HOLLEY BRANCH SUBDIVISION

APPLICATION NUMBER 12 DATE November 16, 2006
APPLICANT Holley Branch Subdivision
REQUEST Subdivision

DETAIL SITE PLAN

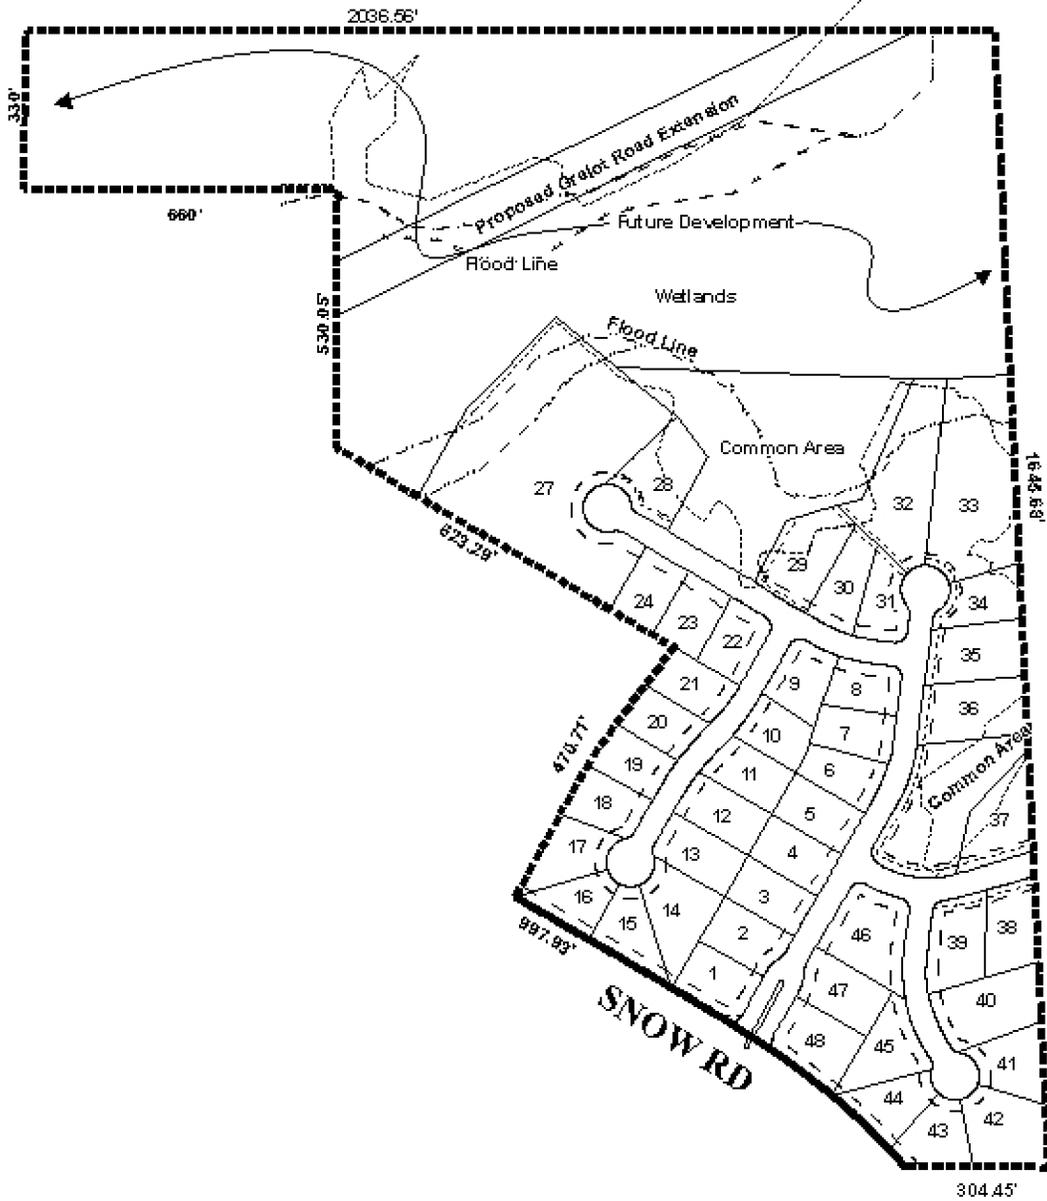
The purpose of this application is to subdivide a portion of two lots (Veasey Estates) into a 48 lot subdivision, with the remainder of a lot and the entirety of a parcel reserved for future development. It should be noted that the future development area appears to contain a part of the recently recorded one lot subdivision called The Grove U.M.C., and thus the preliminary plat should be revised to exclude the portion of The Grove U.M.C. lot.

Snow Road South, which is a planned major street, has an existing right-of-way in compliance with the Major Street Plan. As proposed, lots 1, 14-17, 43-45 and 48 would front both Snow Road South and the new streets. In order to provide proper access management along the major street, the placement of a note on the final plat stating the lots 1, 14-17, 43-45 and 48 are denied direct access to Snow Road South should be required (and is already depicted on the plat). It should also be pointed out that the proposed extension of Grelot Road, a major street, cuts through the future development area of the site, and is depicted on the plat.

As illustrated on the preliminary plat, the site contains wetlands and floodplains, thus this area could be considered environmentally sensitive; therefore, the developer must obtain any necessary federal, state, and local environmental approvals.

Common areas are proposed for the subdivision. A note should be placed on the final plat, if approved, stating that maintenance of the common areas, including stormwater detention facilities if proposed, are the responsibility of the subdivision's property owners.

Stormwater facilities are not depicted on the plat, however, compliance with the City of Mobile stormwater and flood control ordinances will be required. A letter from a licensed engineer certifying compliance with the City's stormwater and flood control ordinances should be submitted to the Planning Section of Urban Development prior to the signing of the final plat, if approved.

This site is located in the County, thus a note should be placed on the final plat stating that any lots which are developed commercially and adjoin residentially developed property, must provide a buffer, in compliance with Section V.A.7. of the Subdivision Regulations.

The plat meets the minimum requirements of the Subdivision Regulations and is recommended for Tentative Approval subject to the following conditions: 1) revision of the plat to exclude the portion

of The Grove U.M.C. subdivision lot from the future development area; 2) the placement of a note on the final plat stating the lots 1, 14-17, 43-45 and 48 are denied direct access to Snow Road South; 2) the developer obtain any necessary federal, state, and local environmental approvals; 3) placement of a note on the final plat stating that maintenance of the common areas, including stormwater detention facilities if proposed, are the responsibility of the subdivision's property owners; 4) labeling of each lot with its size in square feet, or provision of a table on the plat with the same information; 5) provision of a letter from a licensed engineer certifying compliance with the City's stormwater and flood control ordinances to the Planning Section of Urban Development prior to the signing of the final plat; and 6) the placement of a note on the final plat stating any lots which are developed commercially and adjoin residentially developed property must provide a buffer, in compliance with Section V.A.7. of the Subdivision Regulations.
